# UNITED STATES PATENT AND TRADEMARK OFFICE

APPLICATION NO.	FILING DATE	FIRST NAMED INVENTOR	ATTORNEY DOCKET NO.	CONFIRMATION NO.
10/673,945	09/29/2003	Robert J. Stoppek	P06669US0-5178	1641

**Office Action Summary**

## DETAILED ACTION

disposing a wave spring 43 through the center cylindrical bore; forming a hub 12 and disposing the hub 12 through the center bore so that the hub 12 is partially within the cylindrical cylinder block 14. See copy of figure 1 below for what is considered the "flange" and "lip".

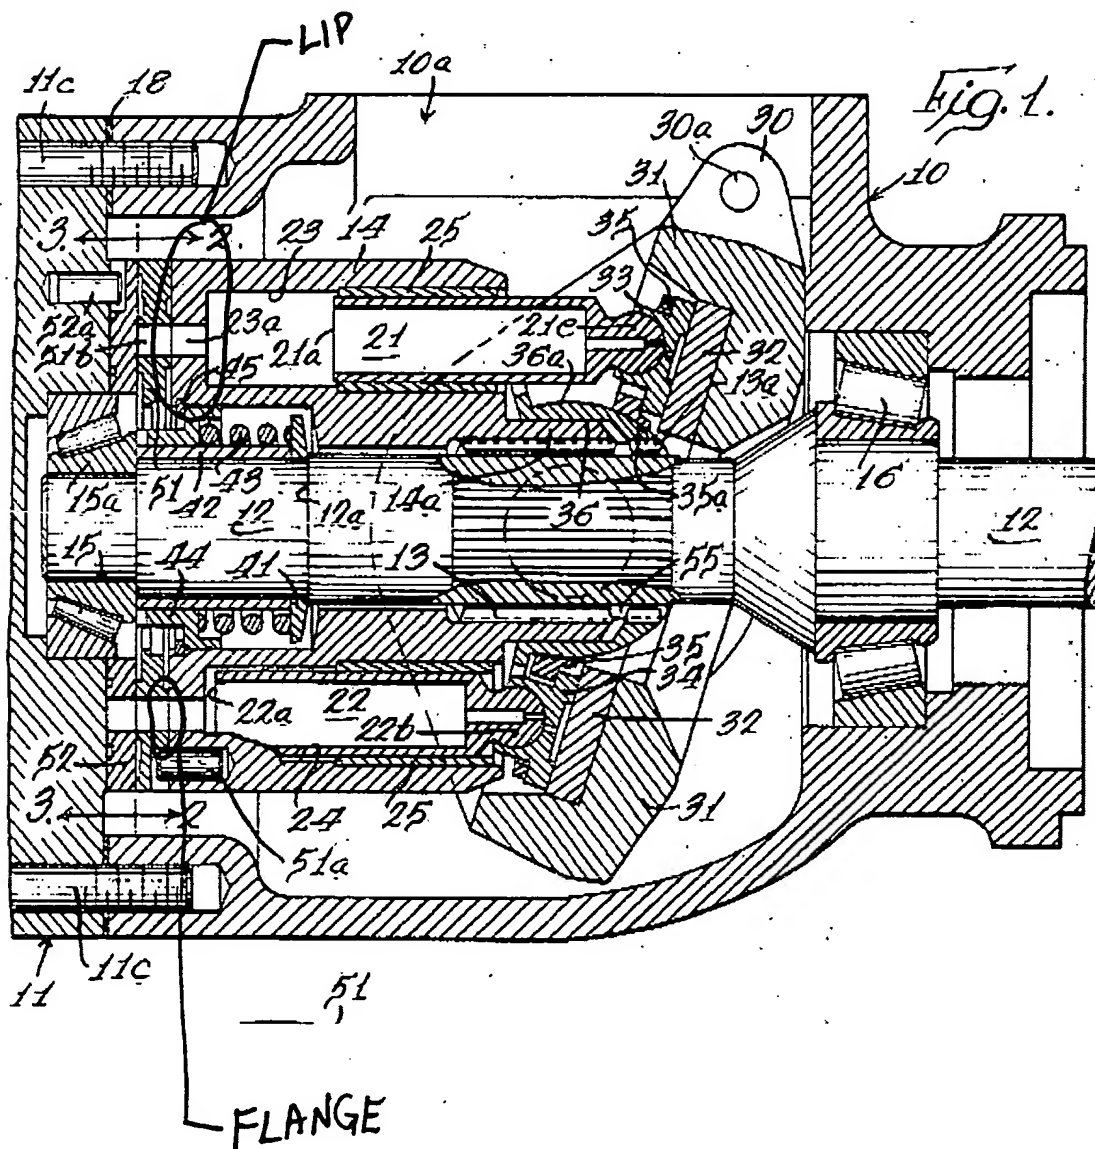
3. **Claim 3** rejected under 35 U.S.C. 102(b) as being anticipated by Moon et al. (US 3,585,901).

Moon et al. teach a method of making a cylinder block for a rotatable hydrostatic power member, comprising steps of: forming a base plate **51** having a center opening with arcuate kidney-shaped uniformly spaced radially located bores **51b** and a flange; forming a cylinder block **14** having a center cylindrical bore, uniformly spaced radially located cylindrical bores **23a** having a smaller diameter than the center cylindrical bore, and a lip that mates with the flange of the base plate **51**; securing the base plate **51** to the cylinder block **14** along the lip and flange;
